Reference: P0898-2

Subject: 93 Bridge Road, Westmead – Response to traffic and transport related submissions on SSDA (SSD-80904224)

Appendix A Swept path assessment

DOCUMENT INFORMATION Swept Path Analysis	
Basement 1 - Car Space 7 - Entry & Exit	
FILE NAME AG0898-2-d01-v06.dwg	SHEET AG_SP02

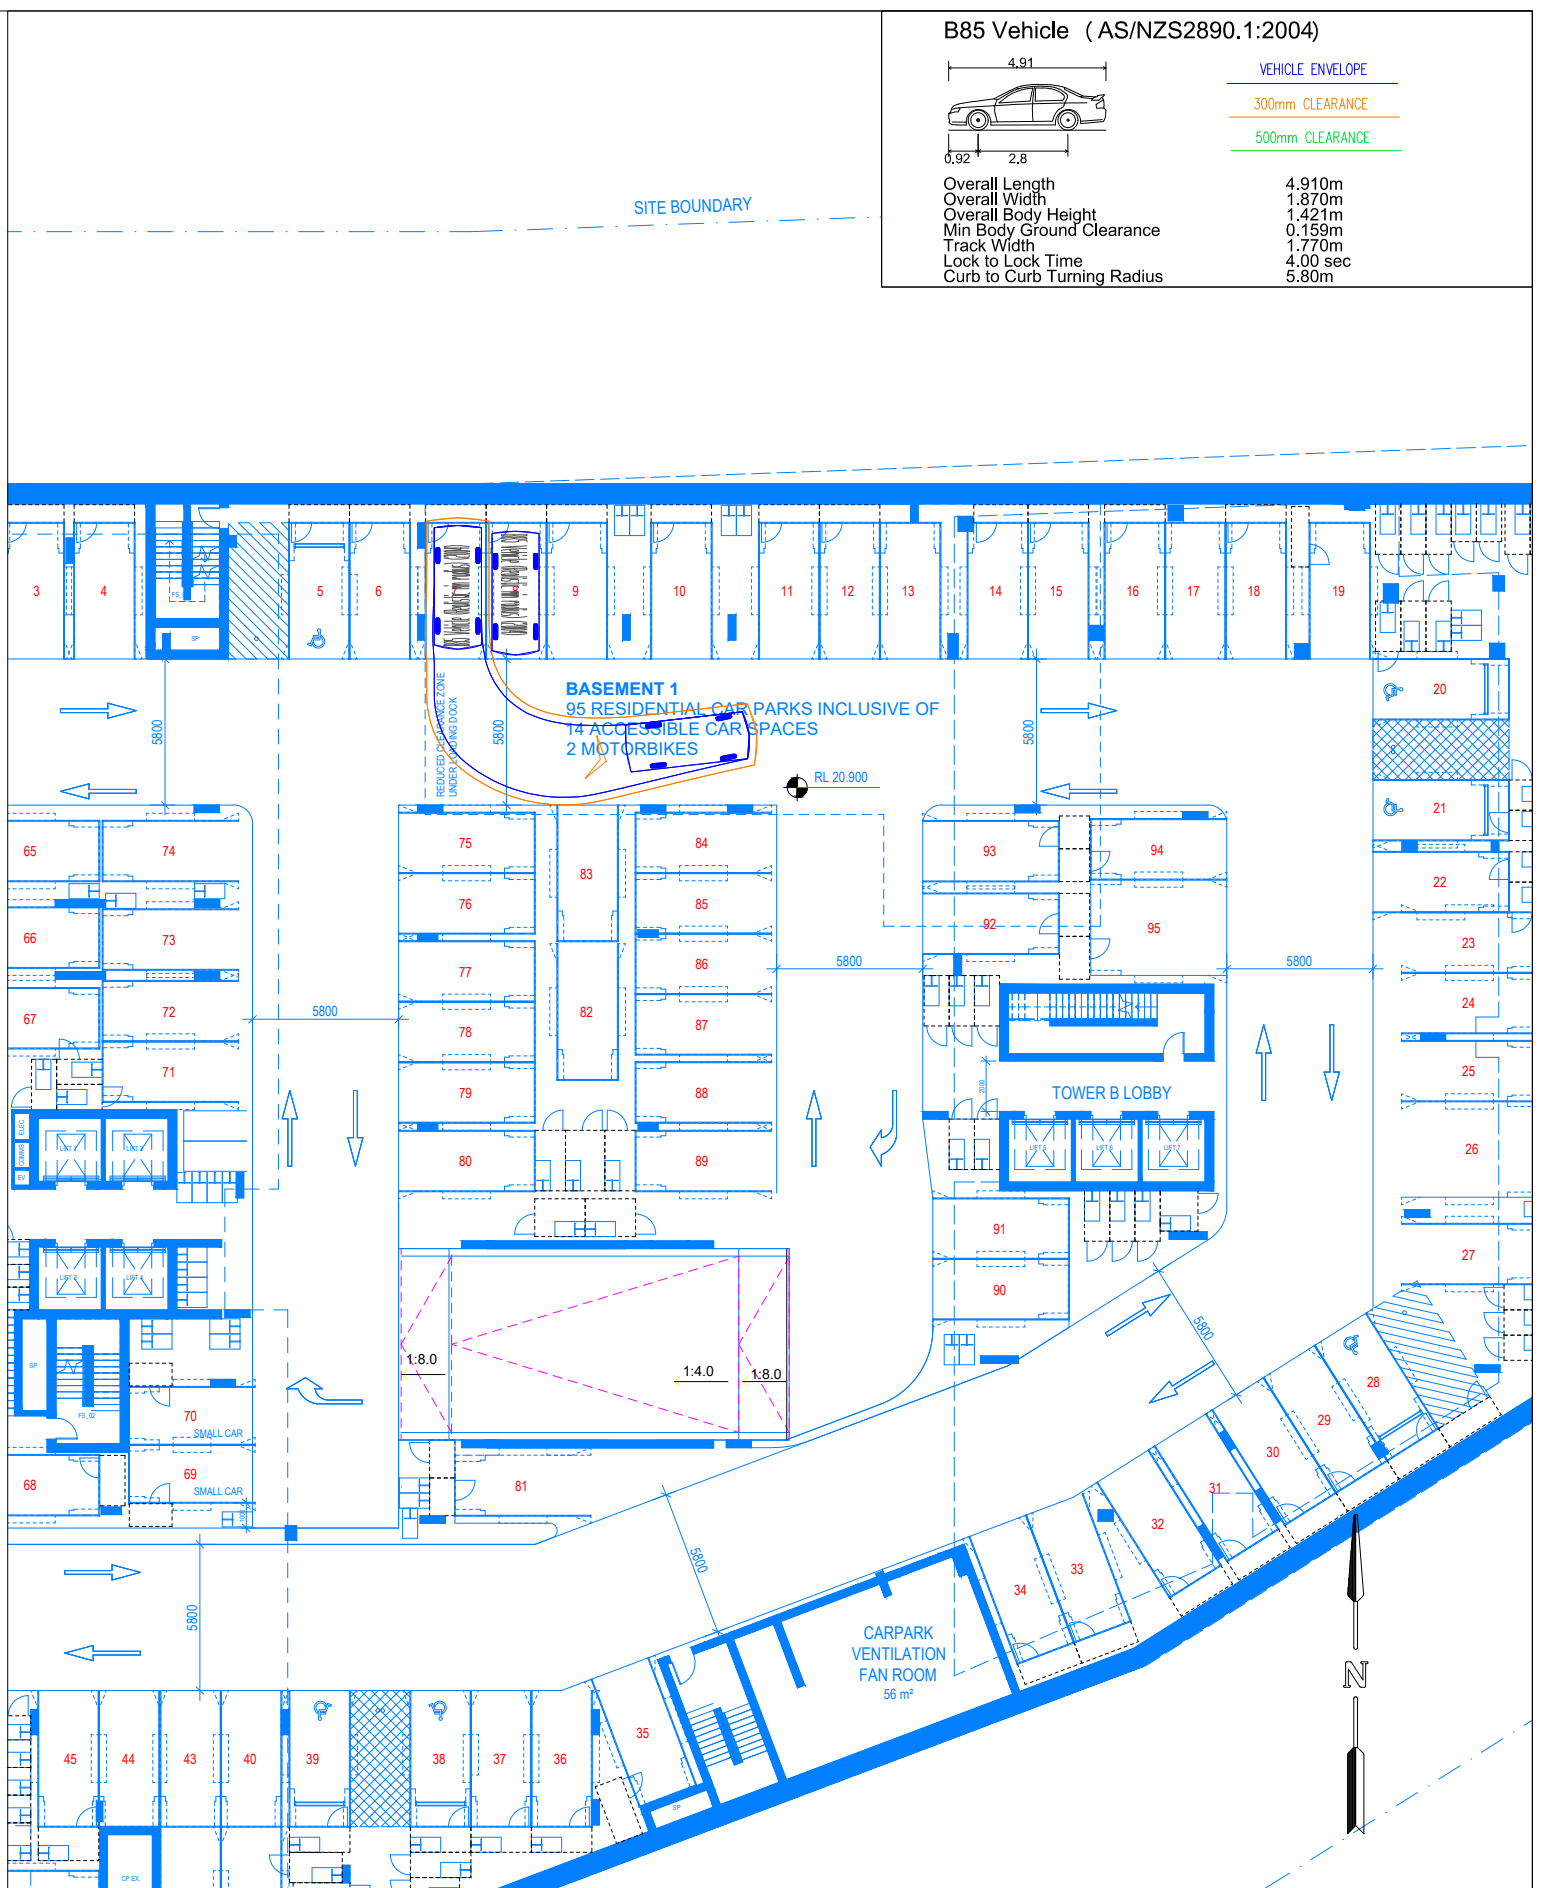
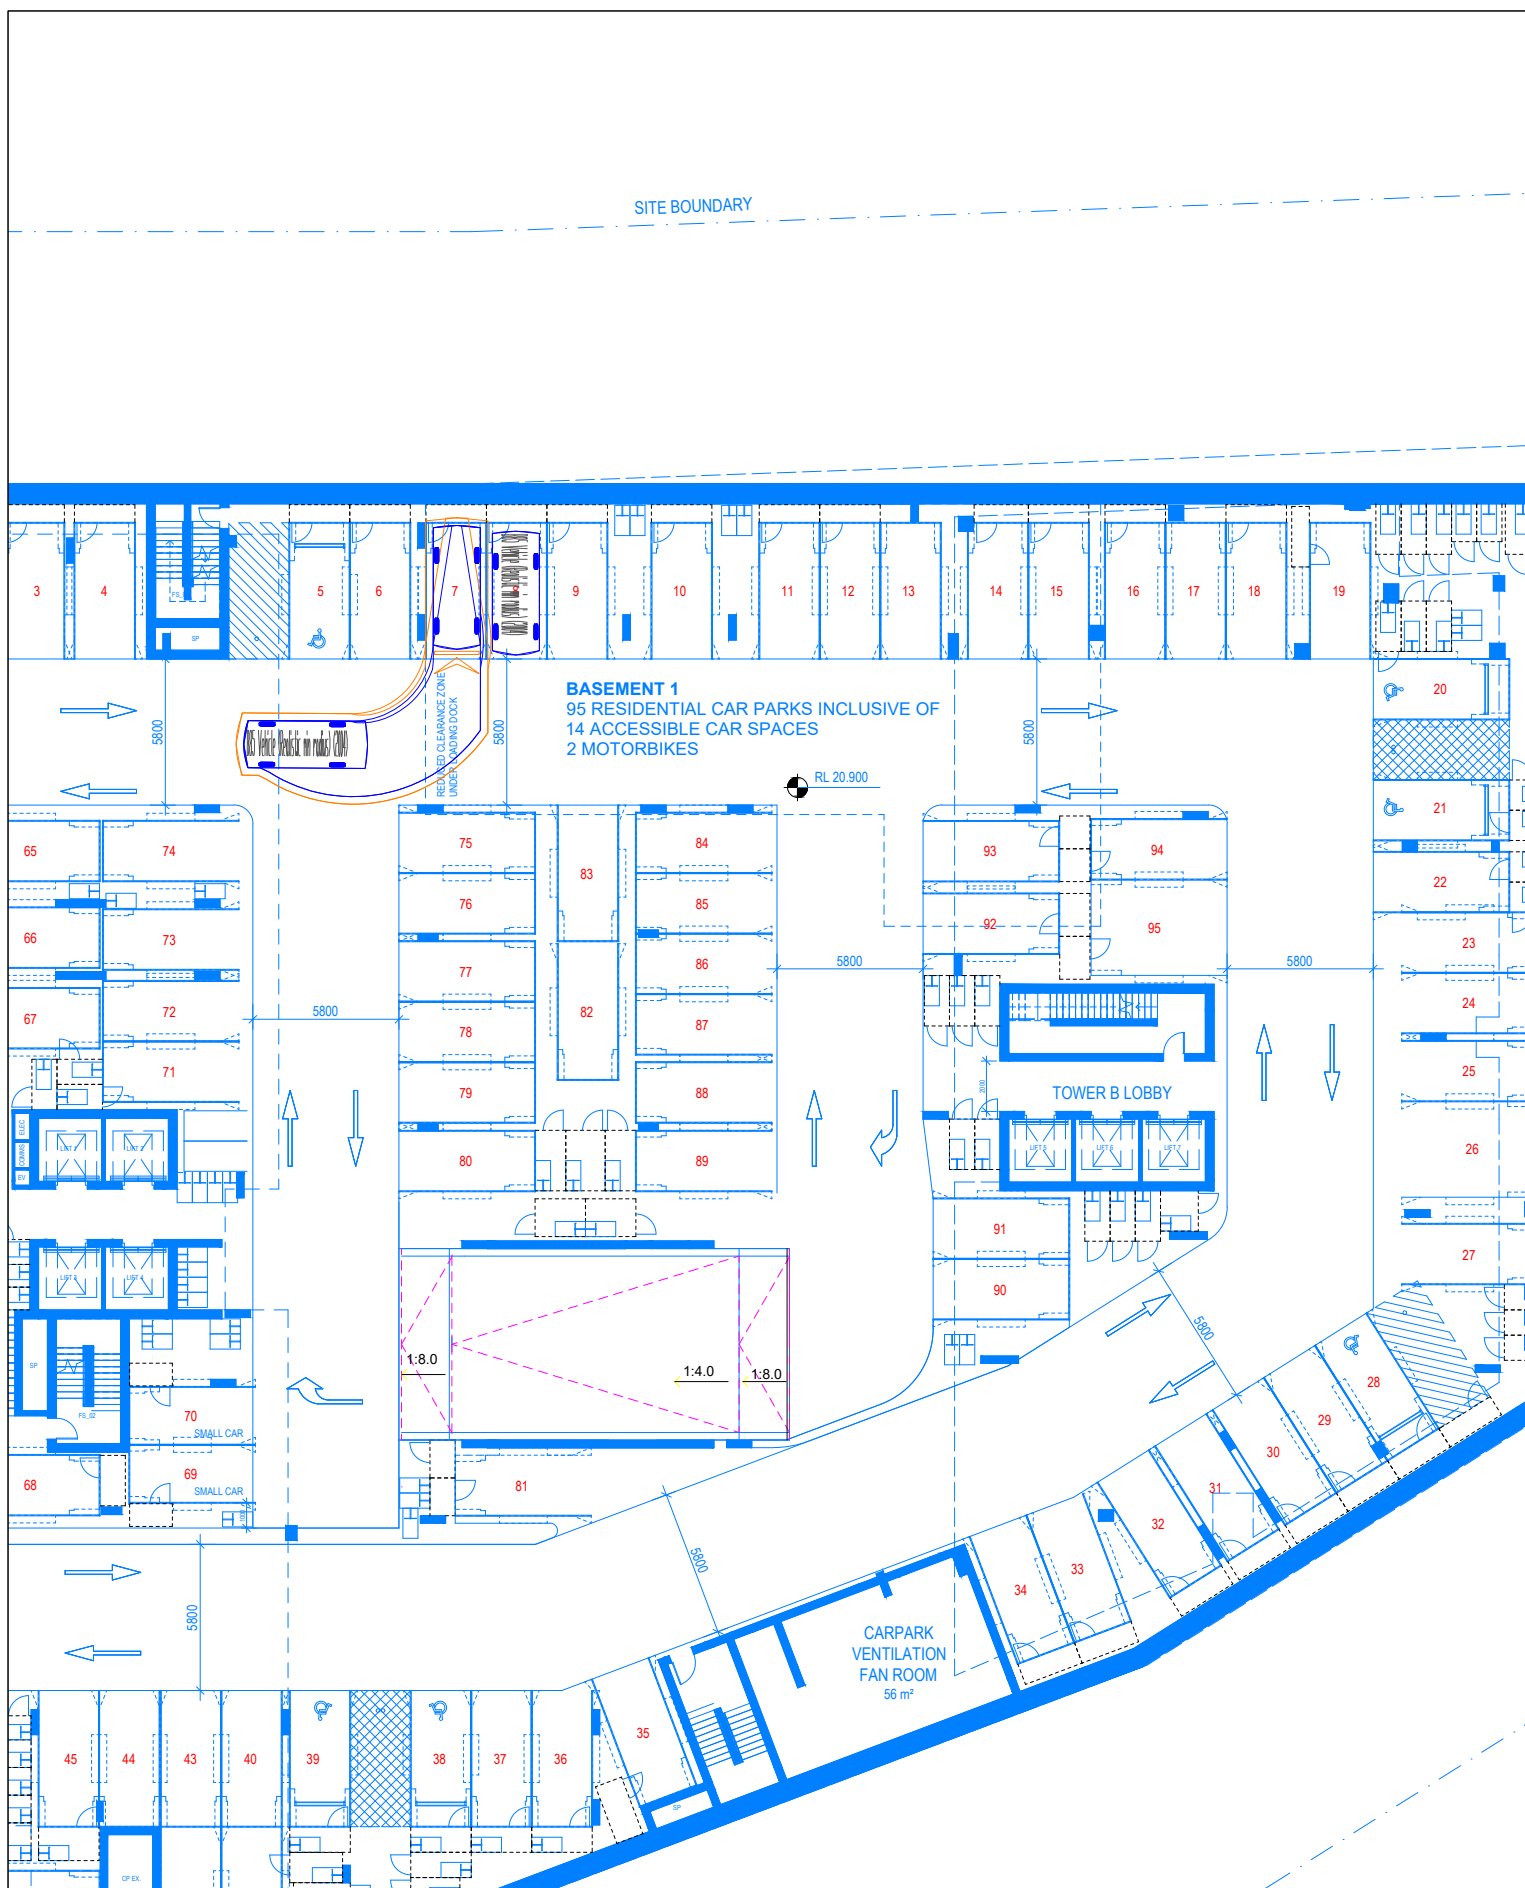
Comment: *Parking spaces adjacent to columns in the basement may obstruct access, reducing aisle widths. Aisle widths must meet Australian Standards, or swept paths should be demonstrated to show that access to spaces can be made with an acceptable number of manoeuvres. Bicycle parking spaces should also be allocated to the same unit to avoid accessibility issues. Standards require the grade for at least 6m prior to the control point to not exceed 5%. However, the 5% grade is only provided for 3m prior to the control point.*

Response: The car parking layout has been designed in accordance with AS/NZS 2890.1:2004 and is subject to further design development as part of detailed design. Spaces and aisles are generally compliant with AS/NZS 2890.1:2004 with respect to the user class. Although certain locations have columns positioned the standard 5.8 metres behind parking spaces instead of the increased 6.1 metres to high structure, constituting a technical non-compliance, these columns represent localised obstructions as opposed to continuous walls and do not materially impact access to the car parking spaces on the opposite side of the aisle. Swept paths are provided in Appendix A confirming suitable access to these spaces is achievable.

Figure 3: Aerial of the Railway line showing TAHE Land and Existing Access Easement.

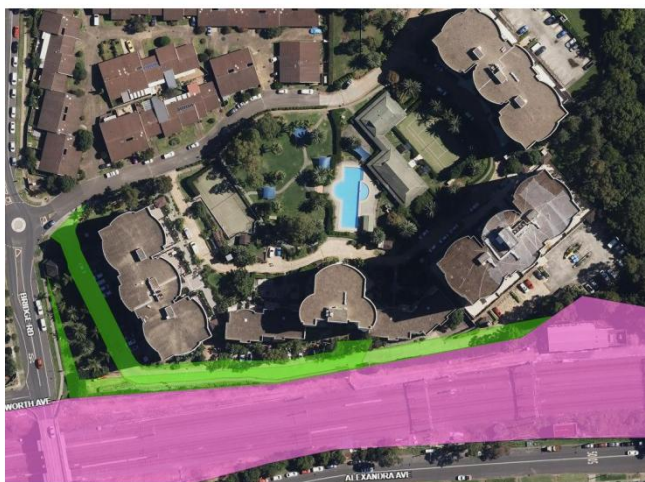
Council should note that there are load restrictions in place and consider a plan of management/safe working method statement for the overbridge at Bridge Road whereby future development is to consider the load and vehicle capacity of the bridge, which also includes any future construction vehicles.

Council should note that Transport Asset Manager (TAM), formally known as Transport Asset Holding Entity (TAHE), has an existing access easement benefitting Sydney Trains that is accessed off the side street at Moree Avenue. This corridor access point is not to be blocked at any stage of any future development (including during construction) and should make provision for easy and ongoing 24/7 access by rail vehicles, plant, and equipment to support maintenance and emergency vehicles. Below is an extract of our mapping system locating the corridor access gate. The legend is provided below in Figure 4.

Any restrictions on construction routes to and from the site would be considered as part of future detailed construction planning for the proposed development by the appointed contractor. Any restrictions would be detailed as part of a future Construction Traffic Management Plan which is typically required as part of the consent conditions.

The proposed development would not impact the existing access easement.
